CALIFORNIA COASTAL COMMISSION

APPEAL STAFF REPORT SUBSTANTIAL ISSUE DETERMINATION

Project description......Nine lot subdivision and construction of nine single-family residences and

Staff recommendation ... No Substantial Issue

path will occupy landscaped As Approved

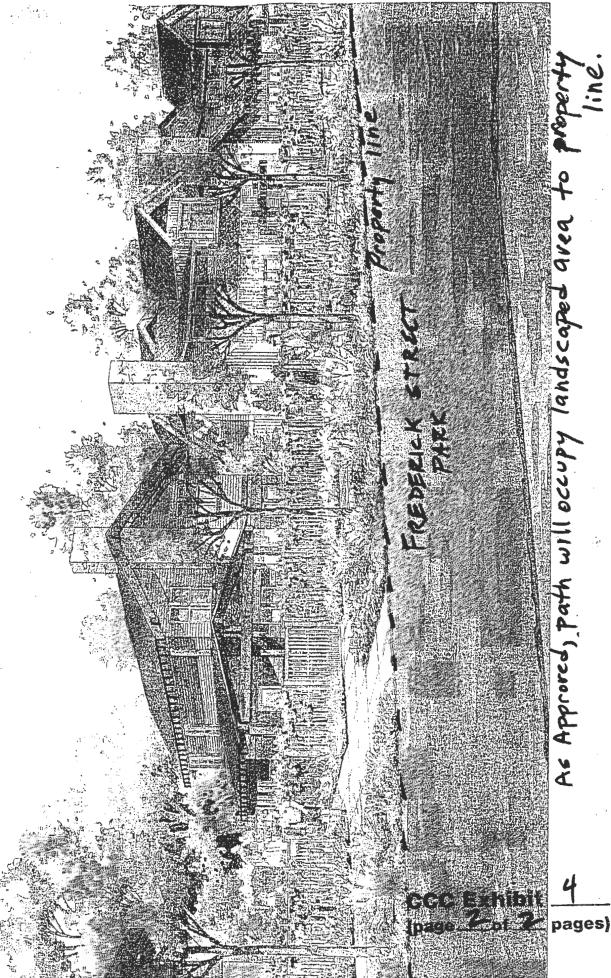
- change the 4' path to 7' path, and if there is a way to make the swale properties work underground, make the path 8', but in any case a 7' path minimum;
- accept the dedication of one of the ADUs as a low to very low income unit;
- require that one of the other ADUs also be listed as an affordable unit as a rental at the moderate income level;
- add \$15,000 to the project for traffic impact fees;
- lower lot #9 unit below the 3,000 square feet threshold;
- that the study in the master bedroom in unit 9 would be moved 45 degrees tangent to the corner of the living room to the satisfaction of staff in order to maximize the view; and
- to change "common" association to "homeowner" association in Condition number 50.
- 36. Light Brown Apple Moth Community & Environmental Advisory Task Force. (CM)

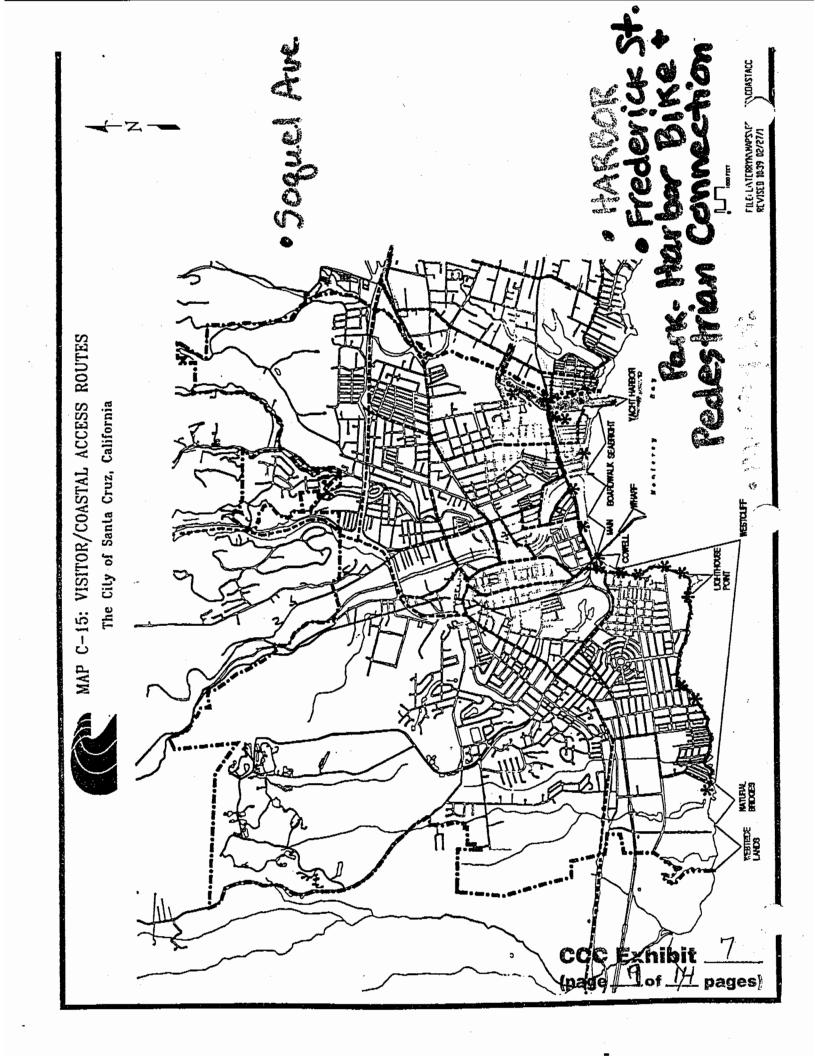
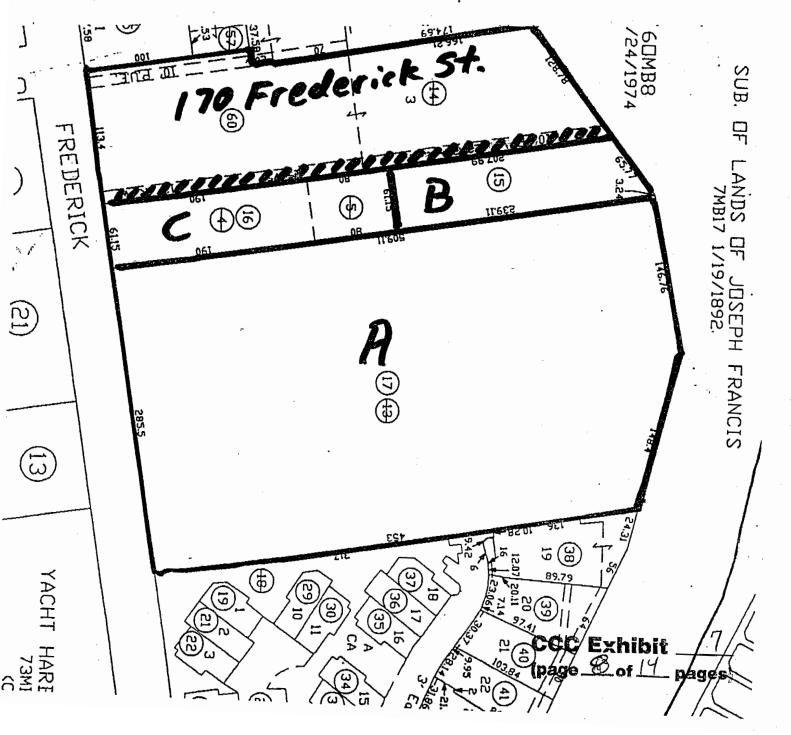
The City presently owns a <u>deeded</u>, 12-foot wide easement over the southern edge of the Property, along its border with Frederick Street Park (this easement is referred to

as the "12-Foot Deeded Easement"). This easement runs almost the full length of the Property, beginning at Frederick Street and extending 395 feet east toward the back of the property and the Santa Cruz Small Craft Harbor (the "Harbor"). The back of the easement is located at approximately the bluff overlooking the Harbor.
